## Variance Request Form

Request Prepared by: Kirstie Reynolds, San Diego Gas & Electric Company  
 Spread/ Location: Section 3 Underground Net acreage affected: 1.5 acres

(Milepost):  
 Alignment Sheet/Sta. Attachment A: Southern Access Road Tract No: 661-04-101-00  
 No.: Refinement – No Longer Required Areas

**East County Substation Project**

**Attachment A: Southern Access Road Refinement – No Longer Required Areas**

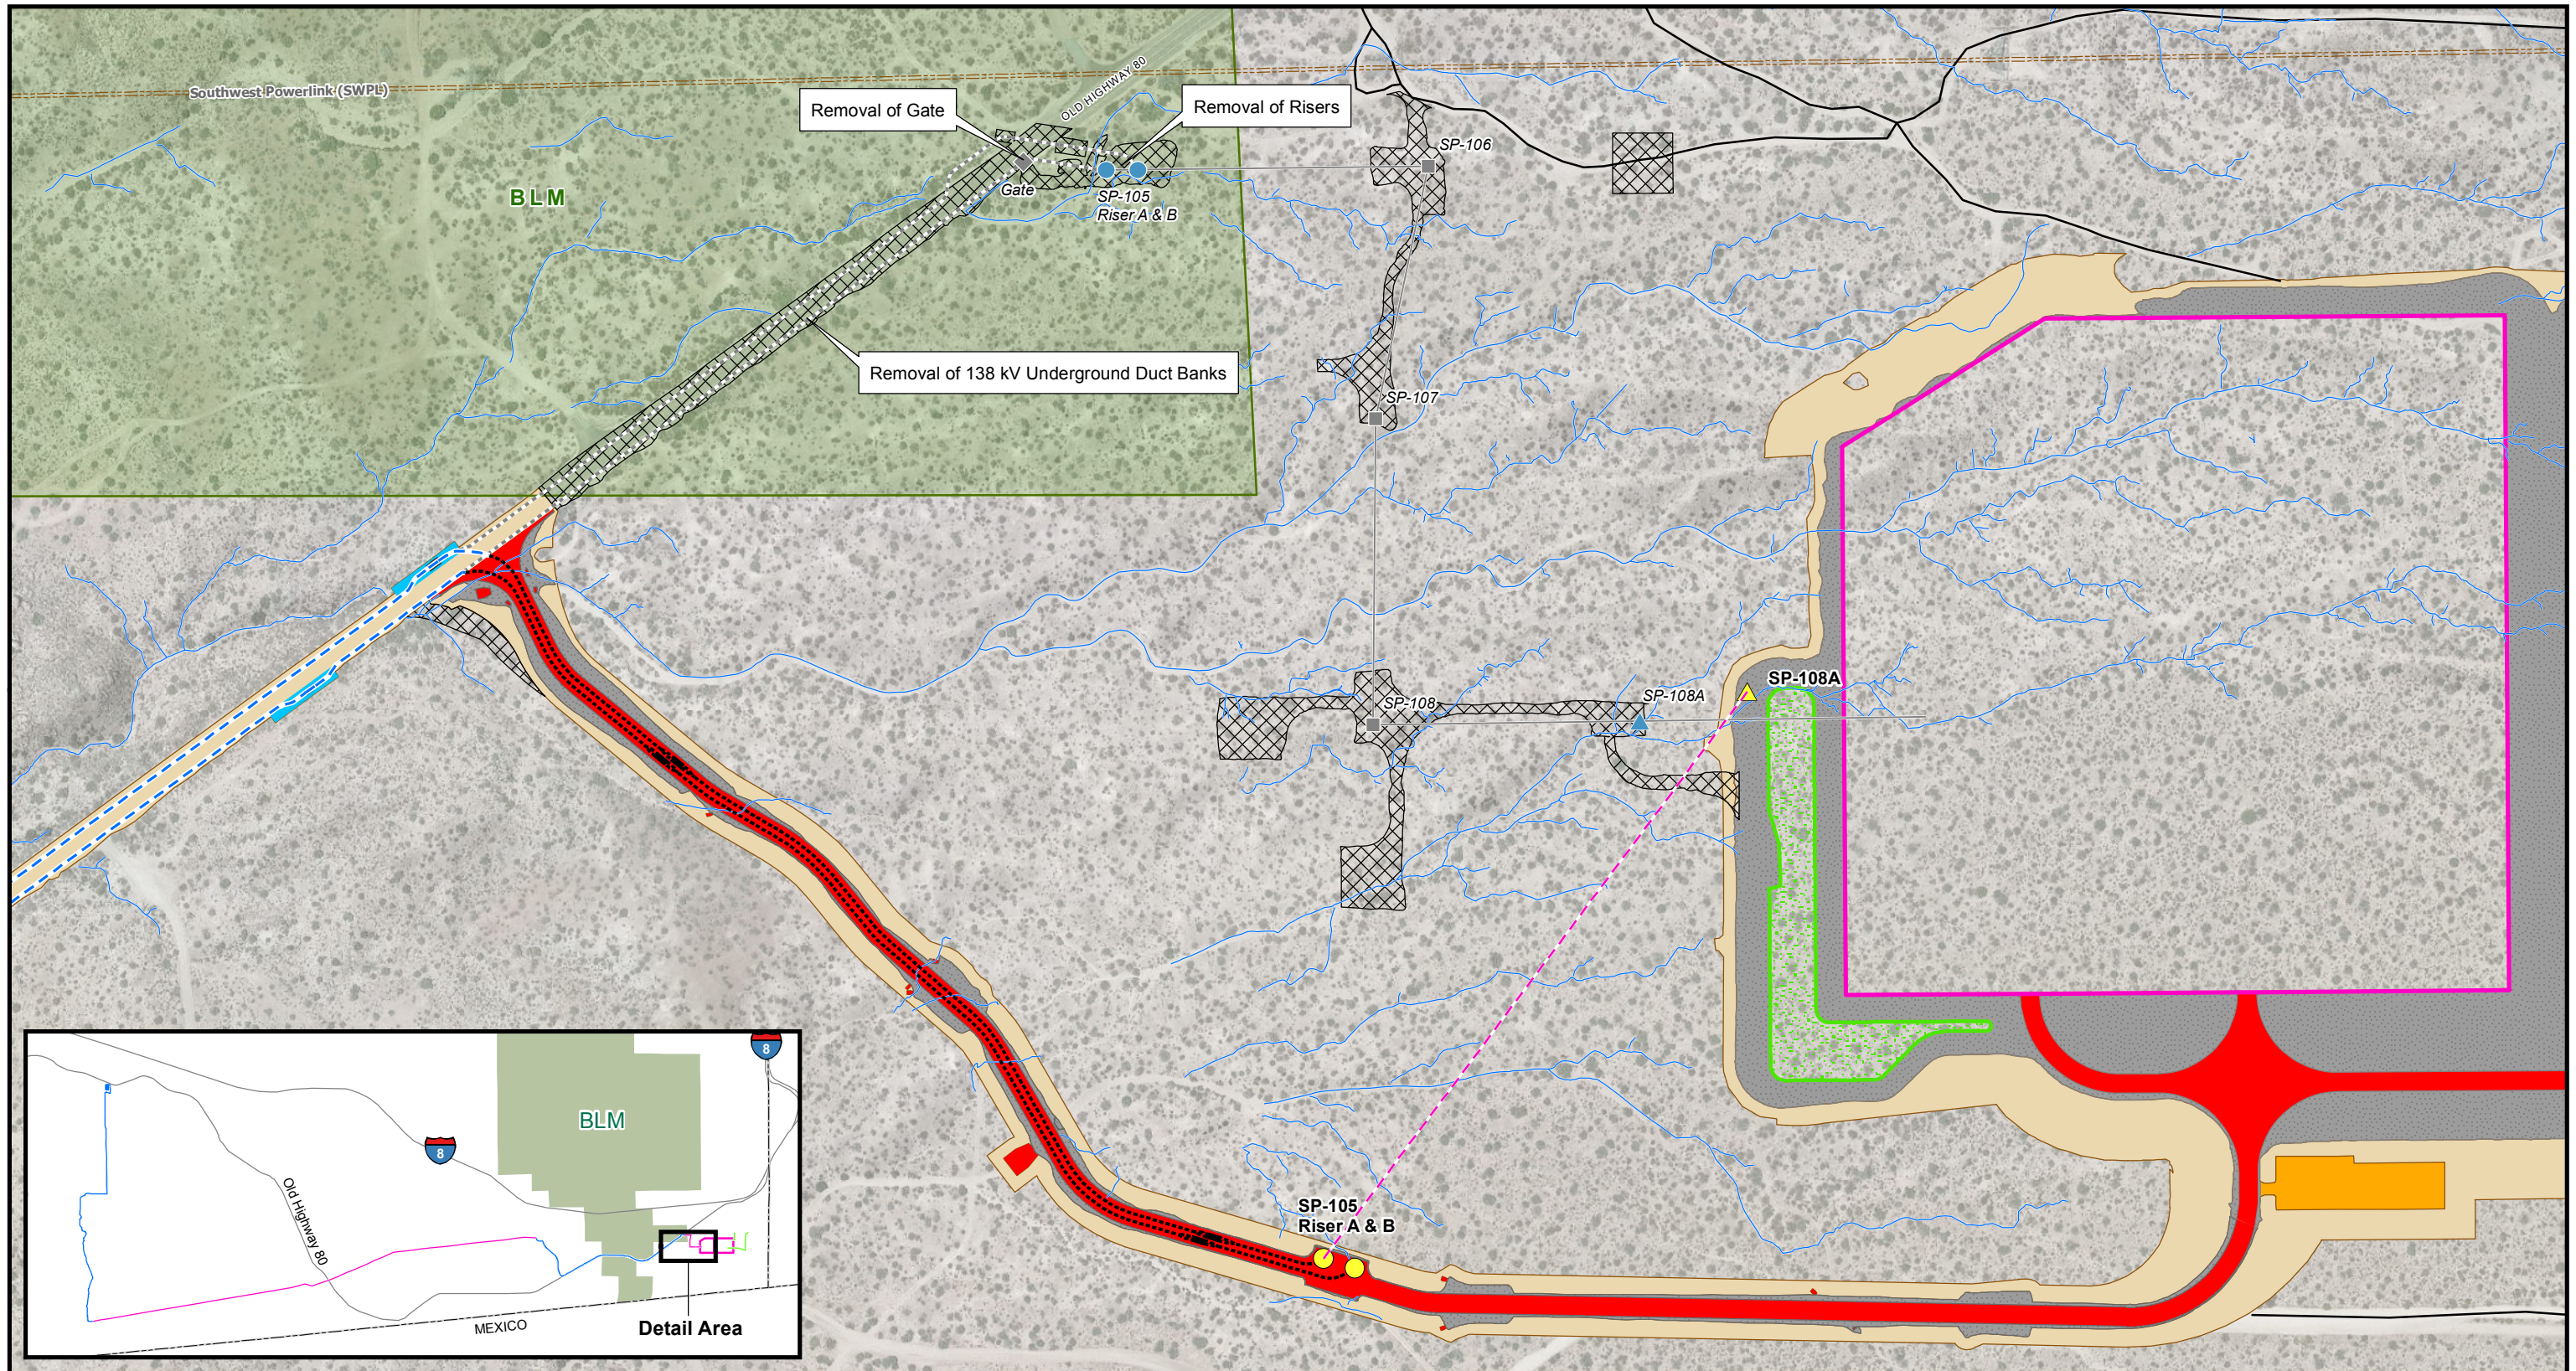
**Detailed Description of Variance:** Attachments? Yes  No  Photos? Yes  No   
 This variance request provides notification to the BLM of San Diego Gas & Electric Company's (SDG&E's) intent to reroute a portion of the 138 kilovolt (kV) underground transmission route and associated transition poles from BLM-managed land to private land. Specifically, the reroute will relocate steel pole (SP-) 105A and SP-105B, and eliminate the proposed gate at Old Highway 80 from BLM-administered land. In addition, the reroute will relocate approximately 1,000 feet of underground transmission line and associated vaults from BLM-administered land to the East County (ECO) Substation's southern access road. In total, approximately 1.5 acres of land in Township 18 S, Range 8 E, Section 2 that is described in Right-of-Way (ROW) Grant CACA-51204 will not contain ECO Substation Project (Project) permanent facilities located above or below ground. The new 138 kV transmission line route and portions of the original alignment that will not be constructed are depicted in detail in Attachment A: Southern Access Road Refinement – No Longer Required Areas.

**Variance Justification:**  
 The reroute of the 138 kV transmission line facilities included in this variance request is proposed to avoid potential impacts to cultural resources. Approximately 1.8 acres of known cultural resource areas, including 0.1 acre on BLM-administered land, will be avoided as a result of the new alignment. The reroute is part of SDG&E's continued efforts to avoid and minimize the effects of the Project on cultural resources.

With the reroute of the 138 kV transmission line and resulting removal of the pads for the poles that were originally sited on BLM-administered land, all of the Project components on BLM-administered lands will be constructed in previously disturbed areas. As a result, permanent impacts to approximately 0.3 acre of juniper woodland on BLM-administered land will be avoided. In addition, temporary impacts to approximately 0.07 acre of juniper woodland and 0.04 acre of mixed desert scrub will be avoided. Because all construction on BLM-administered land will be limited to within the road and the disturbed road shoulder, no native habitat will be
